COMMUNITY BOARD FEEDBACK PACKAGE

COMMUNITY BOARD RECOMMENDATION FORM

Business Name: Ritas

Cafe Address: 756 9 Avenue, New York, NY, 10019

- ### 9th Avenue Frontage

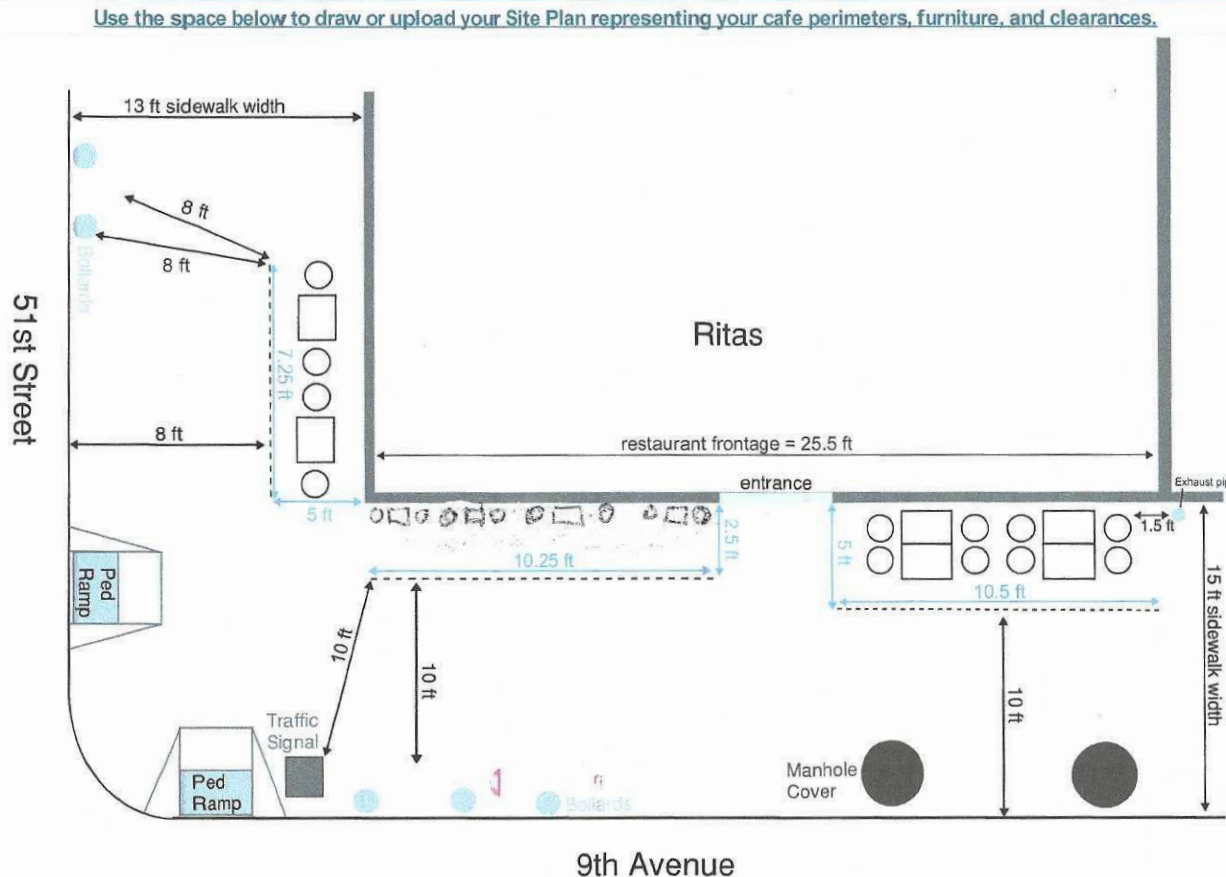
MCB4 and the applicant agreed to add two tables with two chairs each to the left side of the cafe on Ninth Avenue. A Revised Site Plan reflecting this modification is attached.
